**SOLICITATION AMENDMENT
MODIFICATION DE L'INVITATION**

Title - Sujet Griffon Windlass Drive	
Solicitation No. - N° de l'invitation F2599-175088/A	Amendment No. - N° modif. 002
Client Reference No. - N° de référence du client F2599-175088	Date 2017-08-15
GETS Reference No. - N° de référence de SEAG PW-\$\$MD-037-26377	
File No. - N° de dossier 037md.F2599-175088	CCC No./N° CCC - FMS No./N° VME
Solicitation Closes - L'invitation prend fin at - à 02:00 PM on - le 2017-08-28	Time Zone Fuseau horaire Eastern Daylight Saving Time EDT
F.O.B. - F.A.B. Plant-Usine: <input type="checkbox"/> Destination: <input checked="" type="checkbox"/> Other-Autre: <input type="checkbox"/>	
Address Enquiries to: - Adresser toutes questions à: Belcaid, Sidi	Buyer Id - Id de l'acheteur 037md
Telephone No. - N° de téléphone (819) 420-2292 ()	FAX No. - N° de FAX () -
Destination - of Goods, Services, and Construction: Destination - des biens, services et construction:

Questions & Answers
Griffon Windlass Drive (F2599-175088/A)

Windlass Power Breaker Installation

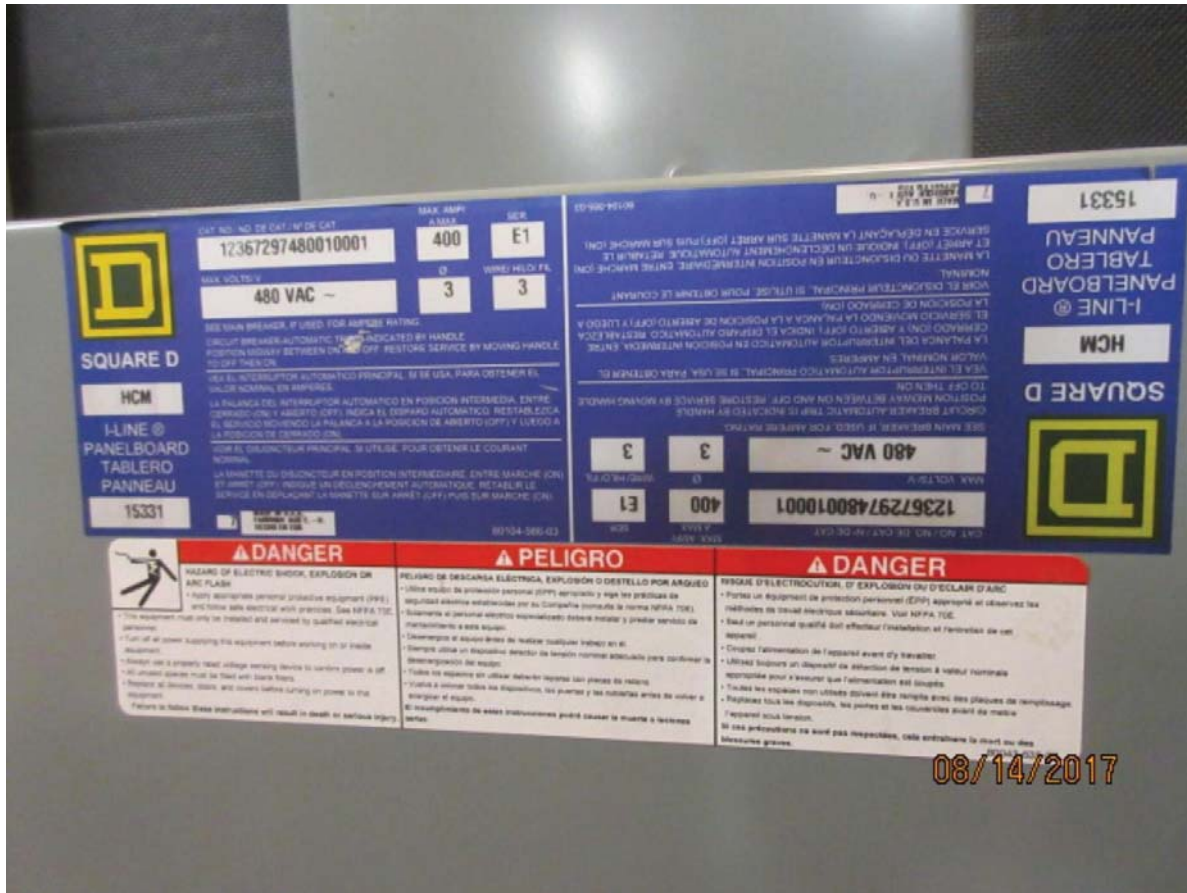
Q8	What are the details of the existing power circuit breaker for the windlass? Manufacturer, type, PN and with curves (if available) and "trip" module values? I think it's the circuit breaker NP-4, circuit 10.	A8	Breaker Square D, Power Pact JG 250, JGA36225, see attached pictures below.
